IDV75FR

F062968

Notes générales

07430-21

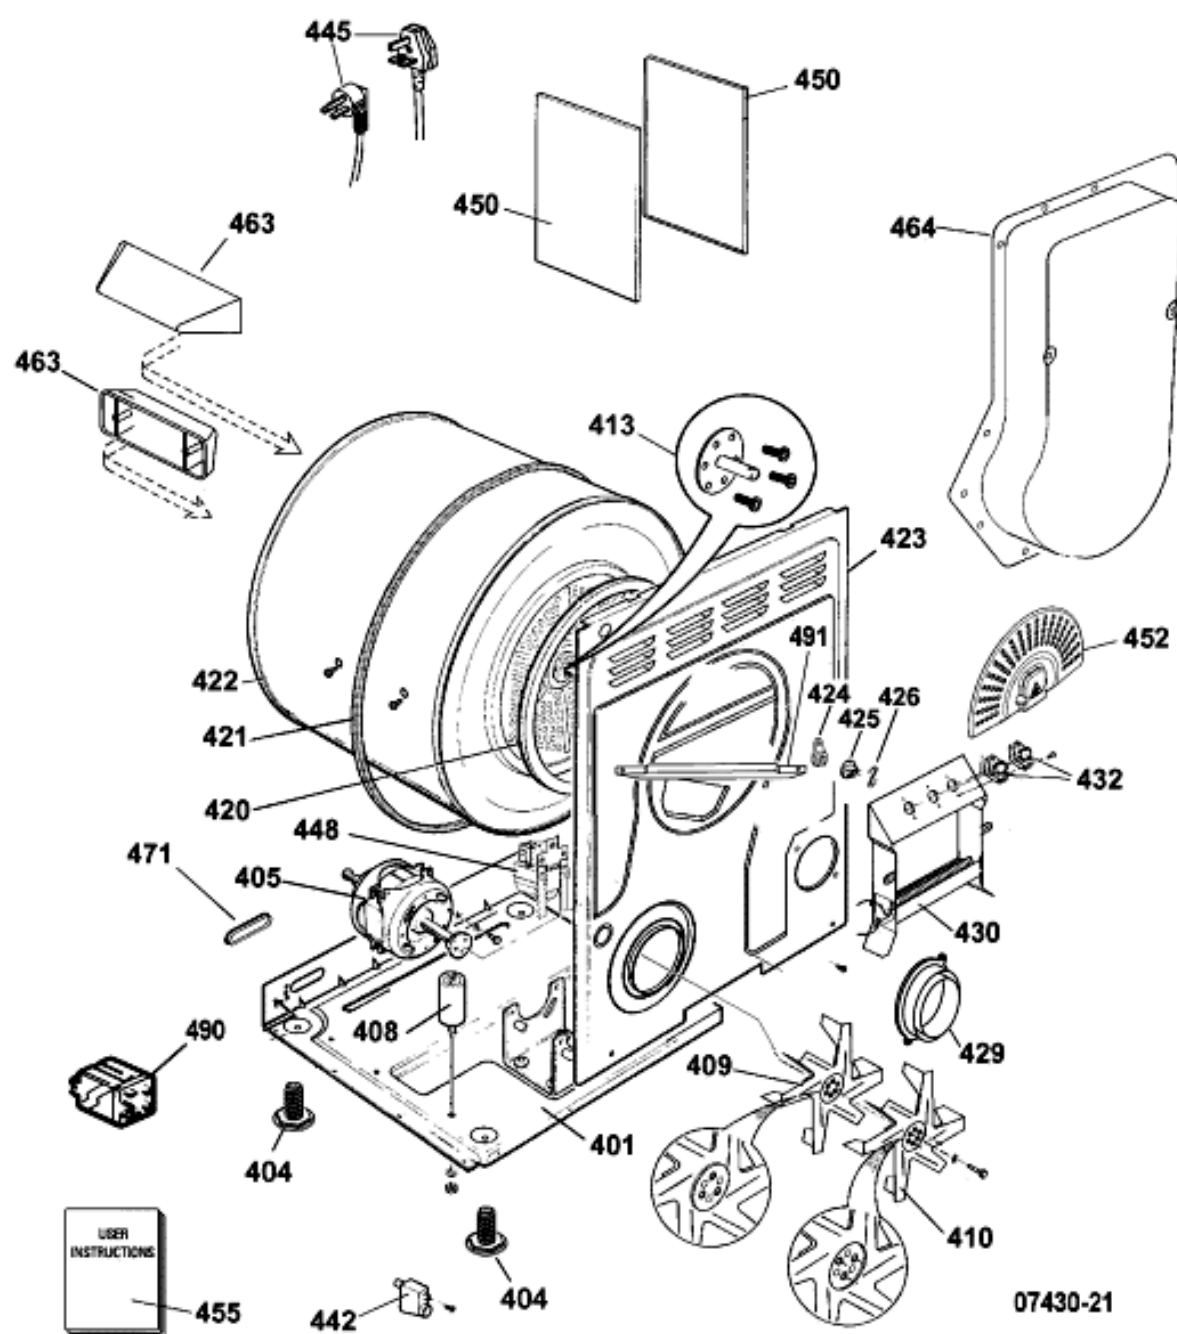
n4408a01: VENTED TUMBLE DRYER HEATERS

From Serial Number 70802.0001, Two different Heater manufacturers were used in production. These DBK and Blaisi Heaters are totally interchangeable if replaced as an assembly.

But the thermostat kits for these Heaters are not interchangeable.

From Serial number 70802.0001, before a Stat. Kit is replaced the heater fitted to the machine must be identified first.

n4408l00: DRUM ASSEMBLY WITH FIXED SHAFT

From Serial Number 80901.0001 a new drum with a fixed (Rivettted) shaft has been introduced in production, this drum is interchangeable and will be supplied as the service spare.

n4410i00: Introduction du moteur of Welling Type 358

A partir du 17/08/2010, numéro de série 00817.0001, introduction en production du moteur type 358 fabriqué par Welling. Ce moteur utilise un condensateur de 9µf.

Le moteur Welling 358 peut être utilisé en lieu et place du moteur type 358 fabriqué par IMEP, mais il convient d'y ajouter le condensateur 9µf.

n4410l01: NEW VENTED MECHANICAL HEATER

FROM SERIAL NUMBER 01207.0000 A NEW HEATER WITH A COLOMBO CONNECTOR HAS BEEN USED IN PRODUCTION.

n4412c01: VENTED TUMBLE DRYER DRUM LIFTER

From Sept 2011, a curved drum lifter, has been used in production, the new lifter is fully interchangeable with the original straight drum lifter, once stock of the straight drum lifter is exhausted, the curved drum lifter will become the Service Spare, for all production dates”.

n4414a00: BUMP STOP

From the Autumn of 2013 2 Bump Stops were added to the rear panel.

07475-05

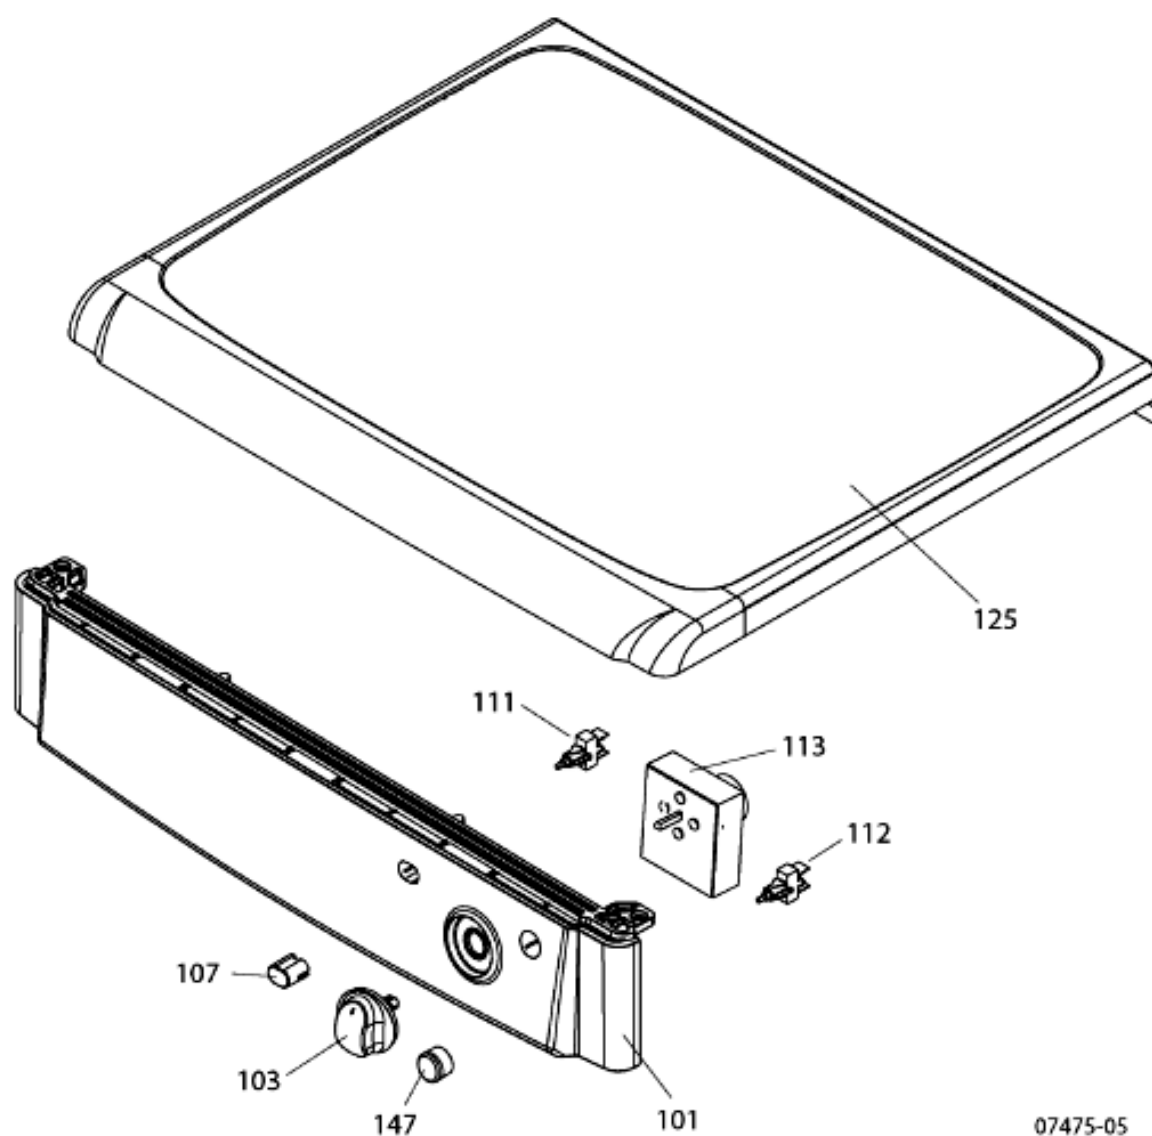
n4412k00: ALTERNATIVE INDESIT VENTED TIMERS/CONSOLE CHANGES

DUE TO PRODUCTION SHORTAGES FROM SERIAL NUMBER 20730.0000 (JULY 30 2012) TO SERIAL NUMBER 21015.0000 (OCT 15 2012) A BITRON ELBI TIMER (16002841700) AND ASSOCIATED CONSOLE AND TIMER KNOB

HAS ALSO BEEN USED IN PRODUCTION.

THIS ELBI TIMER (16002841700) IS NOT INTERCHANGEABLE WITH THE PRODUCTION TIMERS.

THESE MACHINES CAN BE IDENTIFIED BY 16002841700 STAMPED ON THE TIMER AND THE CONSOLE MARKED TO 140 MINUTES

NORMAL PRODUCTION CONSOLES ARE MARKED TO 120 MINUTES DURING THIS PERIOD.

IN A PHASED INTRODUCTION STARTING NOVEMBER 2012 "B" ENERGY CONSOLE ASTHETHICS MARKED TO 140 MINUTES HAVE BEEN USED IN PRODUCTION.

07475-15

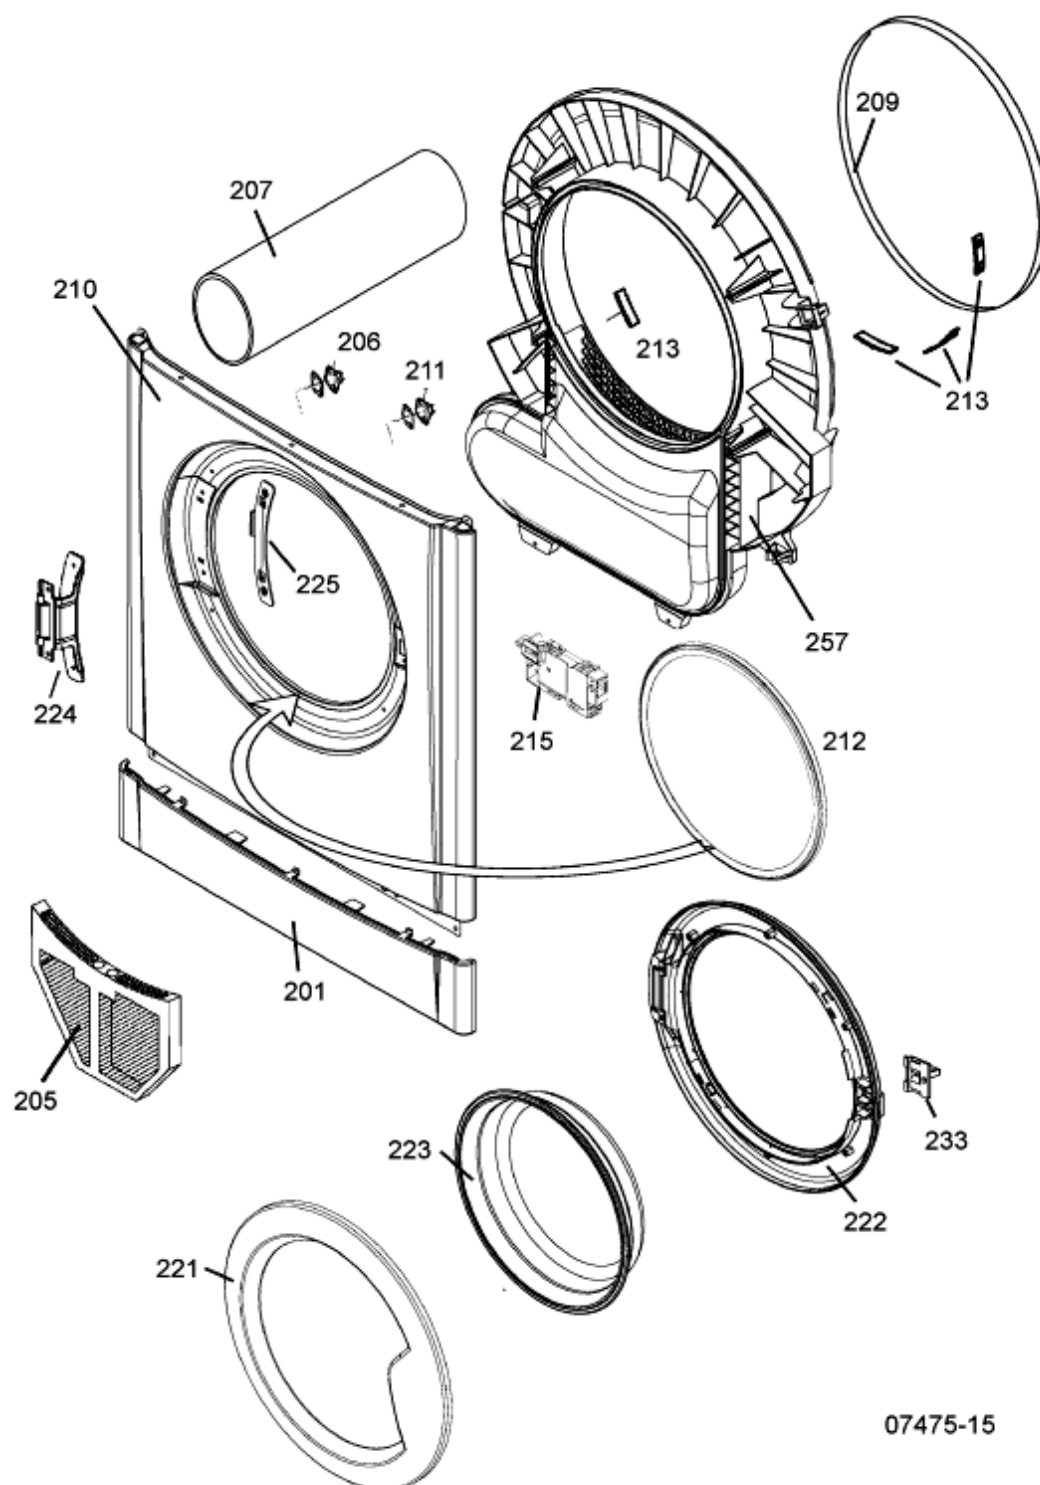
n4411g04: COLOUR CHANGE TO THE FILTER> VENTED DRYERS

FROM JUNE 2011 THE FLUFF FILTER FITTED TO VENTED TUMBLE DRYERS CHANGED IN PRODUCTION FROM GREY TO WHITE.

n4411g06: COLOUR CHANGE TO WHITE FRONT AIR DUCT

FROM JUNE 2011 THE FRONT AIR DUCT FITTED TO VENTED TUMBLE DRYERS CHANGED IN PRODUCTION FROM GREY TO WHITE.
SELECTED THE CORRECT PART BY DESCRIPTION IN THE PARTS LIST

n4414c04: VENTED AIR DUCT

A NEW VENTED AIR DUCT, FILTER AND DRUM FRONT SEAL WERE USED IN PRODUCTION BETWEEN 7th OCTOBER AND 16th OCTOBER 2013 (sn 31007.0000 to sn 31016.9999)

DURING THESE DATES WHEN REQUIRING AN AIR DUCT, FILTER OR DRUM FRONT SEAL, PLEASE ORDER ALL 3 PARTS FROM THE PARTS LIST AND REPLACE ALL 3 PARTS.

n4409k00: FRONT AIR DUCT & AIR DUCT SEAL

Both 14mm and 16mm Air Duct Seals have been used in production.

14 mm - used Before Serial No. 50501.0000 (May 2005) and After 00115.0001 (Jan 2010)

16 mm - used Between Serial No.s 50501.0001 (May 2005) and 00115.0000 (Jan 2010) - See note below

White Air Ducts were used in production from 10601.0000 (June 2011), the only difference to the Grey Ducts is the colour change.

If the AIR DUCT is being replaced you will require a 14mm Seal because the service replacement AIR DUCT is 14mm. See parts List
